Final Revised  
Environmental Impact Report

# Capitol Annex Project

State Clearinghouse No. 2019049066

September 2023

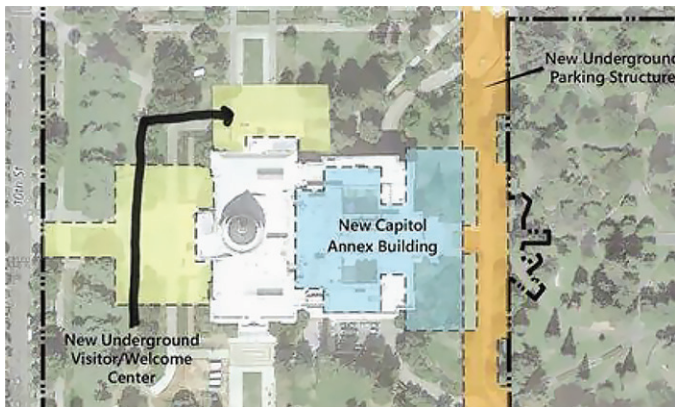
- Keeps 525,000 square feet of functional office and meeting space.
- Keeps the Double T building design so all offices have windows.
- Maintains same floor connections.
- Keeps Galleria entrance and view of 1870 Capitol dome, but reduces its width.
- Ensures Secretary of Interior's Standards met by using similar construction materials to historic Capitol and reducing Annex size.
- Incorporates historic Capitol's architectural rhythm of color, columns, windows to ensure integration of new Annex with existing surroundings.

As the commenter created the suggested alternative, it is assumed that the information on the size, shape, and characteristics of the proposed structure are accurate. An evaluation of the interior configuration of the offices and other facilities would need to be conducted to evaluate whether all offices would have windows. It is clear from the images provided in Comment O5-1 that any offices with windows under the commenter's proposal would have less access to natural light than under the proposed project. A detailed analysis would be required to assess whether the proposal would meet SOIS; however, such an analysis need not be conducted as part of this REIR (see Response O5-1). Based on a very cursory evaluation it does not seem like the proposal incorporates columns as indicated in the last bullet item.

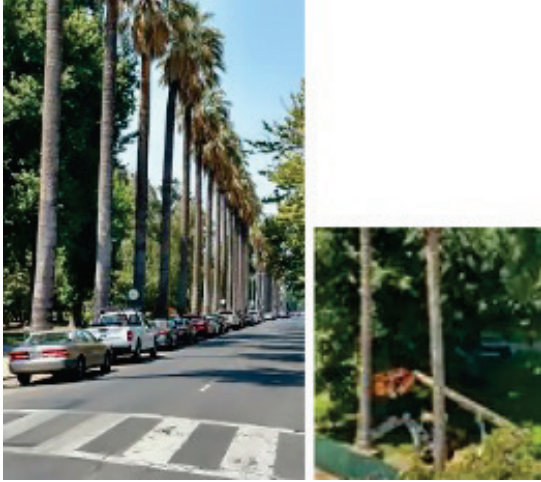
- Find an alternative that minimizes impacts to historic West Lawn
  - Eliminates all impacts to West Lawn by moving Center north of historic Capitol.
  - Eliminates a new structure to primary entrance of historic Capitol (west elevation).
  - Places Visitor Center underground.
  - Retains original park (West Lawn), pedestrian walkways and topography built at the same time as the historic 1870 Capitol.
  - Reduces need for 280 foot (length of football field) concrete ramp which eliminates 35% of West Lawn.
  - Eliminates need for upper terrace which blocks view of 1870s historic Capitol steps
  - Retains open space to continue large celebrations, protests, events, etc.

Any alternative to the visitor/welcome center that is not located on the west side of the Historic Capitol would meet the criteria listed above. This includes Alternatives 4 and 5 evaluated in the Draft REIR. The comment does not provide new information not already included in the Draft REIR. Note that some places where these criteria imply certain characteristics of the proposed visitor/welcome center, they are incorrect. For example, in the discussion of Alternative 5 in the Draft REIR (Section 7.4.5) it is identified that the universal access ramp design for the west entry visitor/welcome center requires a minimum of 174.1 feet of space. This corresponds to the actual design length. There is no 280-foot concrete ramp proposed as part of the visitor/welcome center. In addition, nowhere in the 2021 EIR or the Draft EIR is there an estimate of 35% of the West Lawn being eliminated, nor any estimate of the percentage of West Lawn disturbance specifically connected to the proposed ramp or any other visitor/welcome center facility. No information is provided in the comment regarding how the provided estimate of disturbance/elimination percentage was derived.

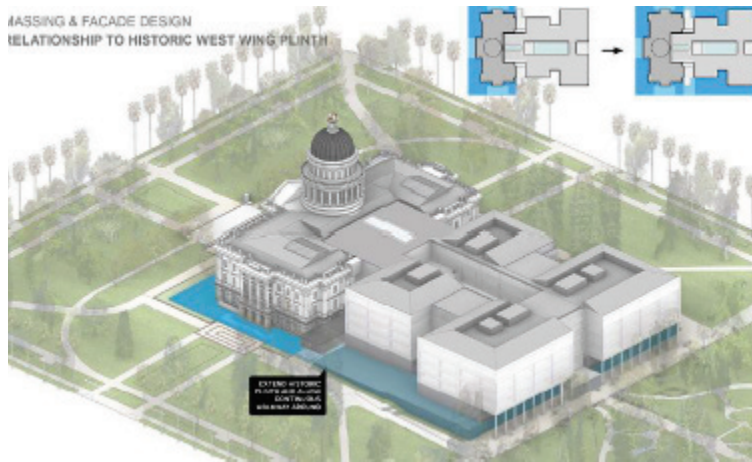
Proposed New Visitors Center at the Main West Entry eliminates public gathering on a large scale. It also provides a 280-foot ramp with high terraced sides not usable by the public for large events.

The 2020 Recirculated Draft EIR and Draft REIR both recognize the visitor/welcome center's contribution to the significant unavoidable impact on the Capitol Complex. The comment provides information that aligns with the content of the Draft REIR. Please also see Master Response 2.

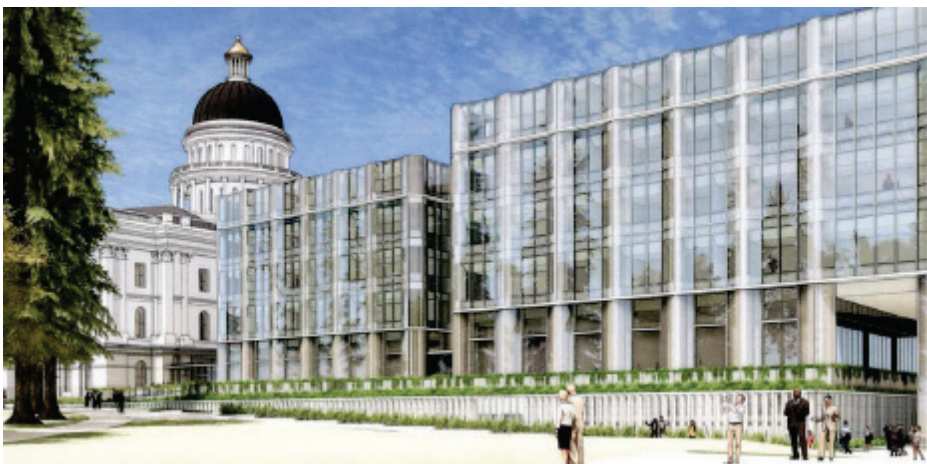
The new Annex disrespects and overshadows the iconic dome with its large size and reflective glass facade. It denigrates the most important historic governmental landmark in California. The new Annex is substantially over size for the existing historic Capitol and results in the diminution and loss of the historic character of the Capitol. The edges of the new Annex stick out beyond the footprint of the Capitol making the new Annex superior and overbearing to the Capitol.

The proposed new Annex greatly impacts the east, north and south elevations of the 1860-1874 Capitol by introducing a large reflective glass structure and the historic Greek Revival style of the historic Capitol. The new proposed Annex also is one story higher than the existing historic Annex and impacts the historic 1874 Capitol dome.

The new addition is significantly different in terms of materials (granite, concrete and stucco versus reflective glass), openings (no defined openings are visible compared to the window and doorway openings of the historic Capitol), the architectural rhythm of the colonnades, and the horizontal lines and the roofline that define the Capitol. The large glass facade is so foreign to the materials and openness of the historic Capitol that it is significantly different and incompatible. The large glass structure is not consistent with the architecture and stature of the original Capitol.

Each of these design aspects of the proposed Annex are analyzed against the SOI Standards in the discussion of Impact 4.12-4 in the Draft REIR (pages 4.12-20 through 4.12-23). As shown in Figure 4.12-3, the proposed Annex will be the same height as the top of the parapet on the Historic Capitol. The effect will be that the proposed Annex will appear to be the same height as the Historic Capitol and will not overshadow it in any way. In the same way that the Historic Capitol sits below and supports the capitol dome, the proposed Annex, which is the same height as the Historic Capitol, will sit below and appear subservient to the dome. As shown in Figure 3-3, the portion of the proposed Annex closest to the Historic Capitol has a footprint that recedes from the outer line of the footprint of the Historic Capitol and also has deeper recessions immediately adjacent to the historic building, both of which demonstrate the proposed Annex building’s subservience to the Historic Capitol. Figure 3-5, Double-T Perspective View, Looking North and Figure 3-6 Capitol Annex Double-T Design – Reveals Historic Capitol Eastern Facade illustrate how these recessions will allow portions of the east façade that have been obscured by the existing annex for decades to be restored and enjoyed by

The exterior treatment of the new Annex achieves compatibility and deference to the Historic Capitol with its use of horizontal and vertical rhythms that align with the Historic Capitol's exterior rhythms. The new Annex emulates the Historic Capitol's tripartite division of base, middle, and cornice where the pleated glass wall's glass parapet and shadow box aligns with the Historic Capitol's balustrade, a horizontal reveal aligns with the bottom of the Historic Capitol's cornice, and the lowest stack joint aligns with the Historic Capitol's water table (see Figure 4.12-3 and Figure 3-5, bottom image). Similarly, the Historic Capitol's strong vertical rhythm established by the use of Classical columns and the stacked alignment of large windows is emulated by the stone shadow box at the base and white ceramic frit coating in the glass above those shadow boxes that will give an appearance of a curved protrusion that will evoke the columns and pilasters on the Historic Capitol (see Figure 4.12-3).

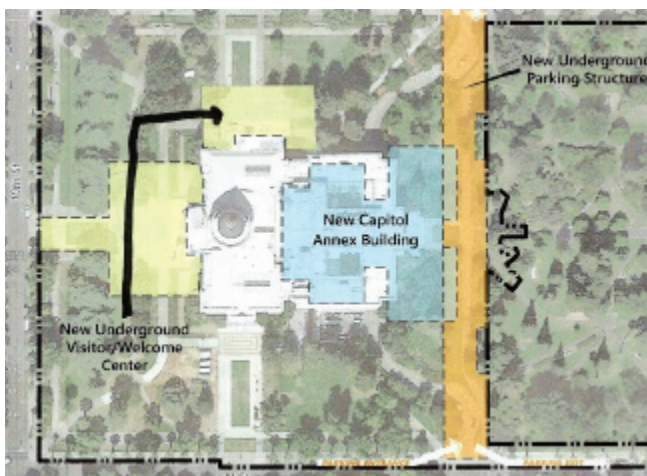
The Revised Draft EIR offers reasons as to why Alternative 5 “Visitor/Welcome Center South Entrance, page 7-13 cannot be accomplished. The reasons do not stand scrutiny. The RDEIR considers the proposed footprint of the western location of the Visitor Center with its extremely long down ramp entrance and alleges that neither the north nor south locations is far enough from L or N Street to accept the long downward ramp. However, the distance from the outside face of the granite porticos to the street is substantially the same on the north, west, and east facades of the 1860’s Capitol. So the fit of the ramp should be substantially the same.

Moreover, the analysis does not but should consider alternates to the ramp entrance. Since the protected west view corridor would not be affected by either a north or south visitor center location, the use of stairways and elevators such as those proposed in the recirculated Draft EIR of January 2020 could be used taking only 60 feet of distance. There is more than enough room for such an entrance on either the north or the south side of the Capitol.
